Detailed Site Plan (Amendment) DSP-2026-0004

Capital Plaza Eastern Pad Site

STAFF REPORT

SUBJECT: Detailed Site Plan (Amendment) DSP-2026-0004
Capital Plaza Eastern Pad Site

G. L. W. FILE No. 01190
SHEET C 41

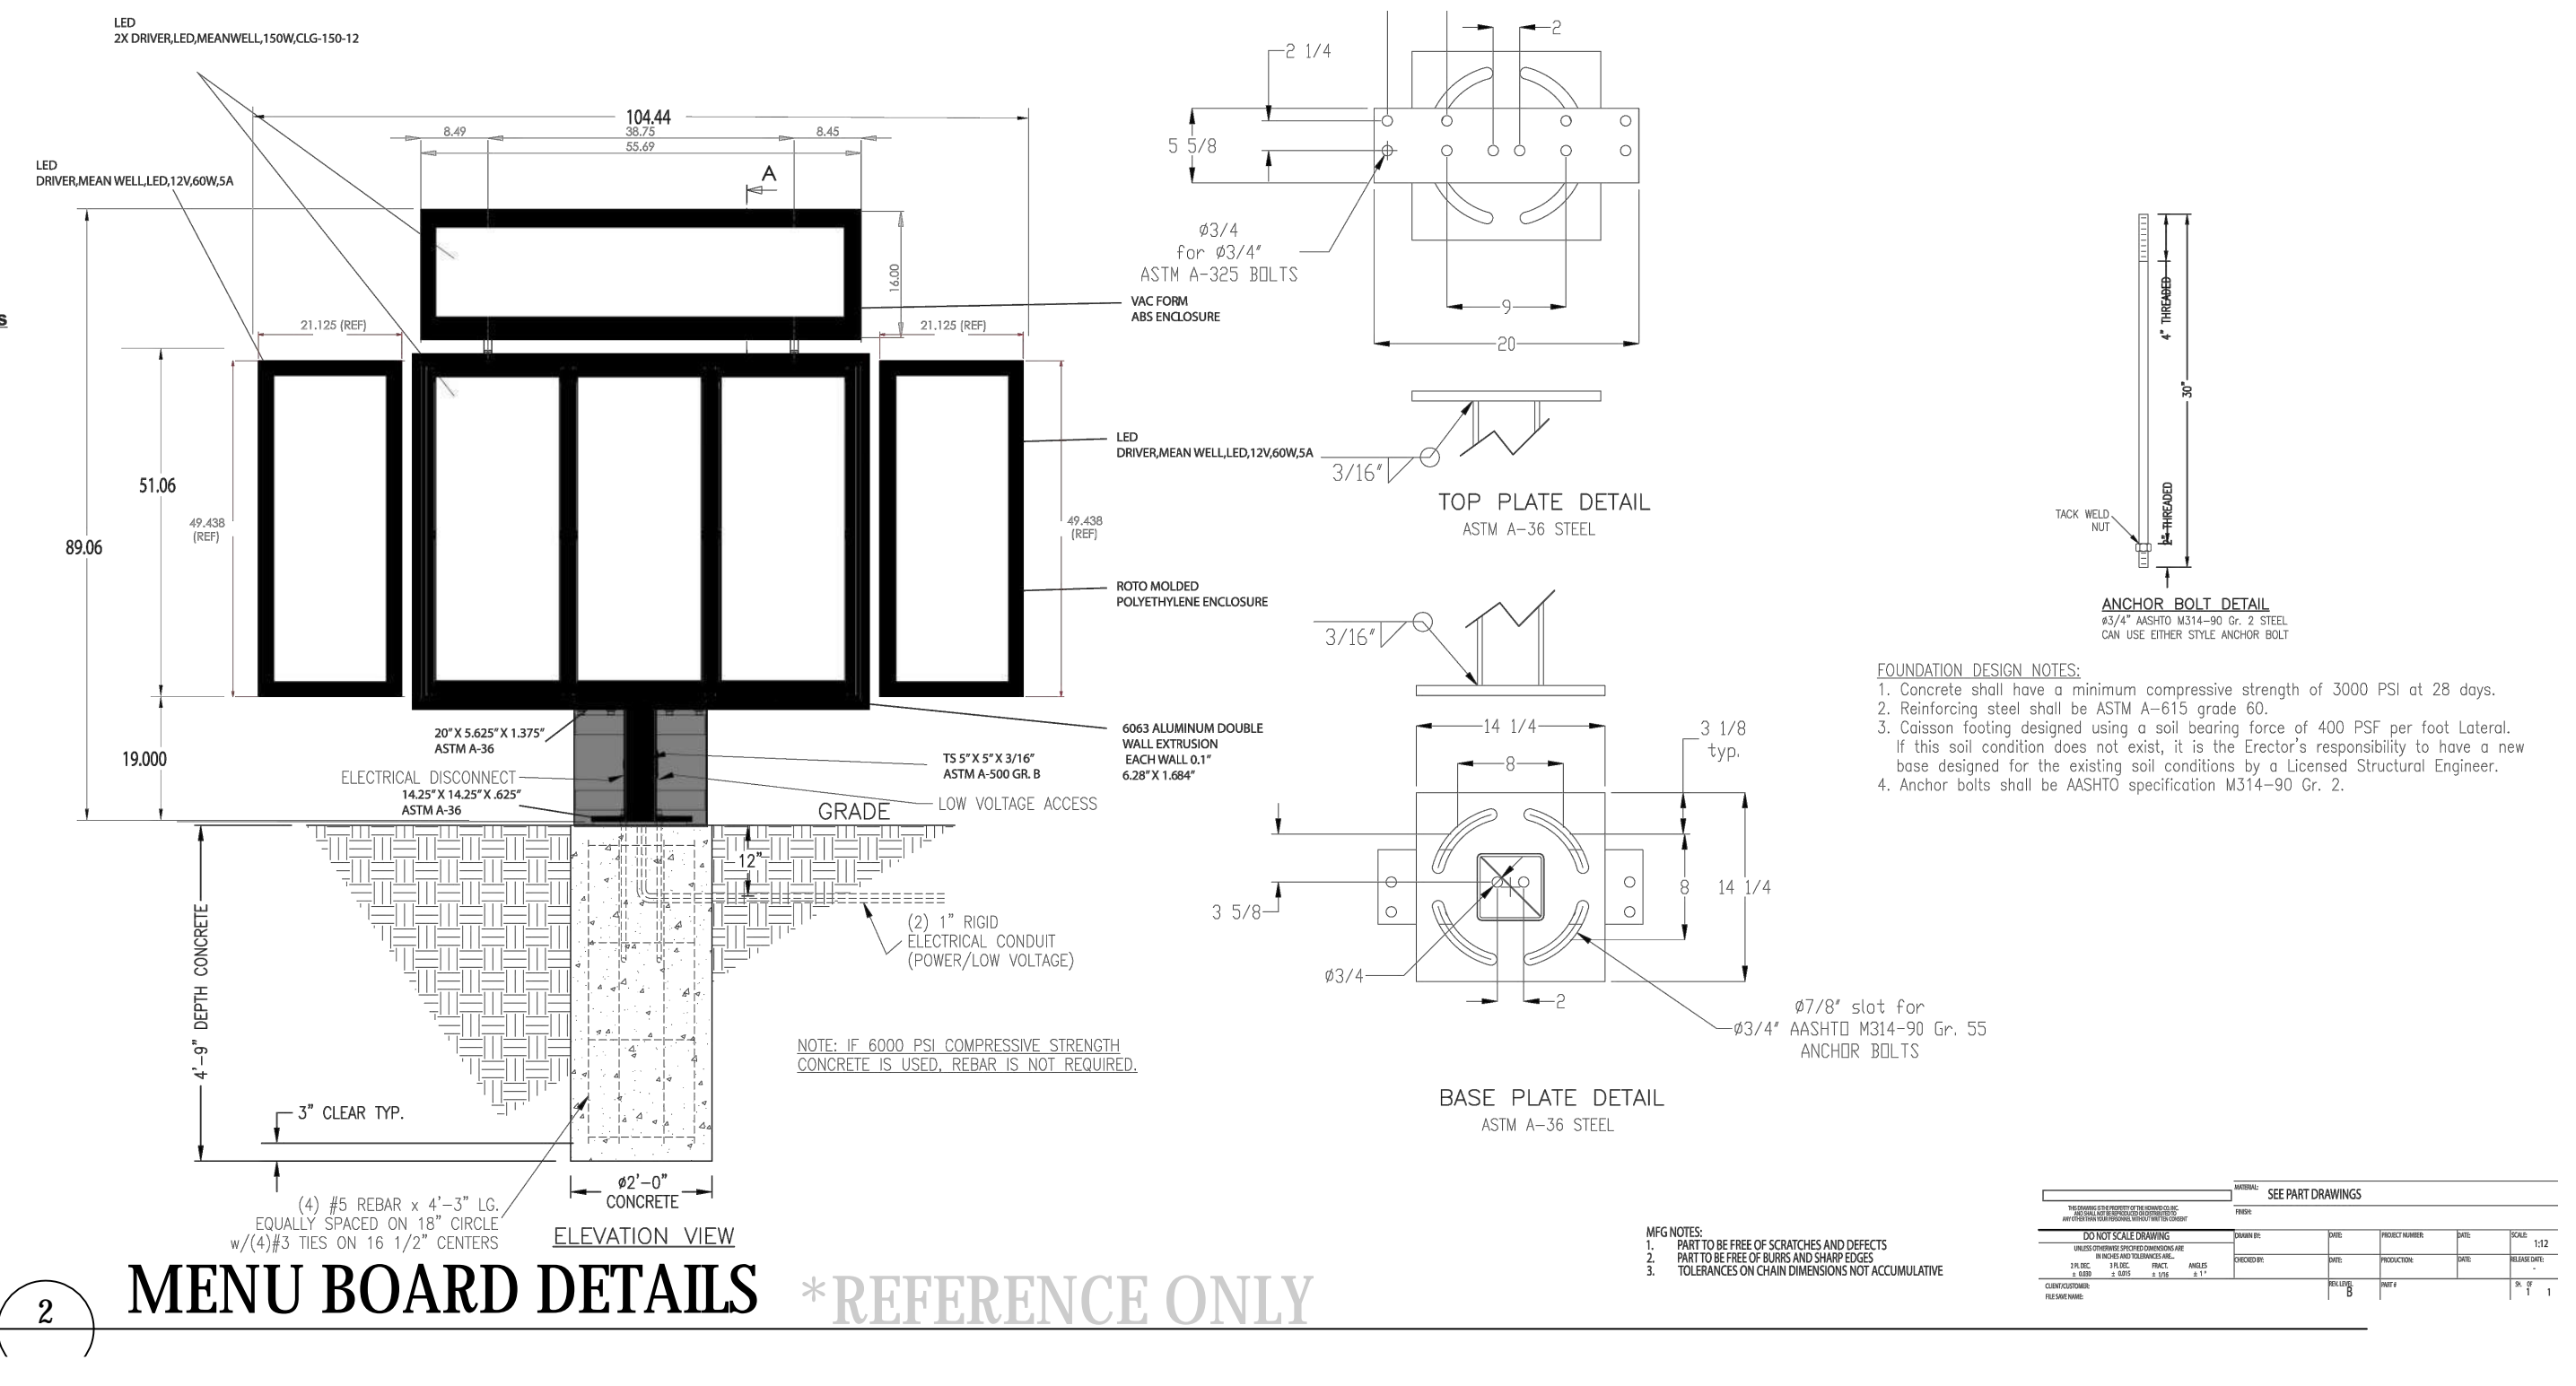
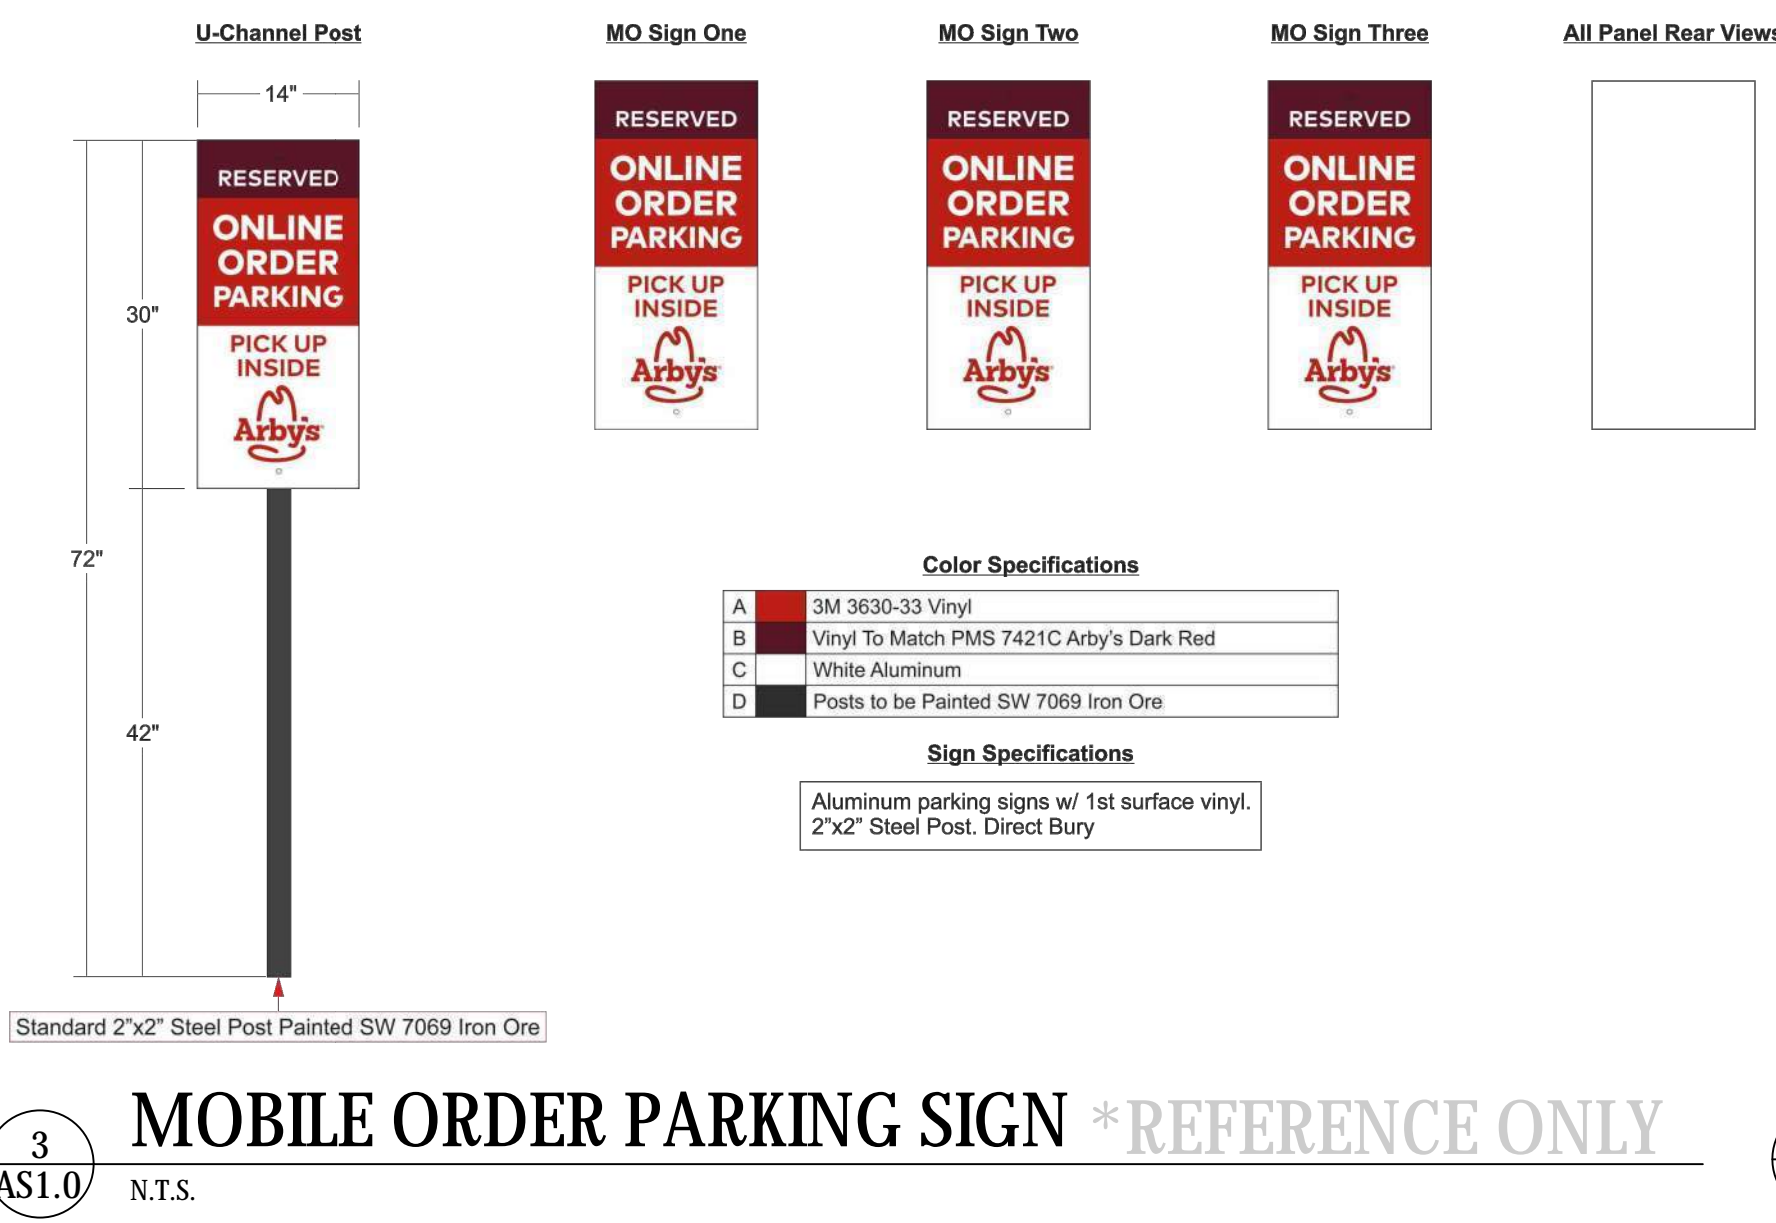
Sheets C-41- C-44 of the plan set includes a variety of small, customary signs for a drive-through restaurant on Parcel I, including wall signs, channel letters, directional signage, pre-order menu board, a mounted illuminated drive-through sign, a clearance bar, and order point canopy. Pursuant to the applicability section of the *2010 Approved Central Annapolis Road Approved Sector Plan and Sectional Map Amendment* (Sector Plan and SMA) Development district Overlay Standards, “[t]he regulations and requirements of the Prince George’s County Zoning Ordinance apply to the DDOZ unless the Central Annapolis Road development standards specify otherwise.” (page 137) The DDOZ outlines the various sign regulations on pages 180-181. These standards have been analyzed, and are included on the DDO chart located on Sheet C-3 of the plan set.

from Part 12 with the DSP.” The subject DSP does not include a request for an amendment for building-mounted signage, as proposed. Additionally, no freestanding or monument signs are proposed with the subject DSP. Staff has requested that the Applicant analyze the sign regulations contained in Section 27-613 of the prior Zoning Ordinance. Although not applicable, the Applicant has included these regulations on sheet C41.
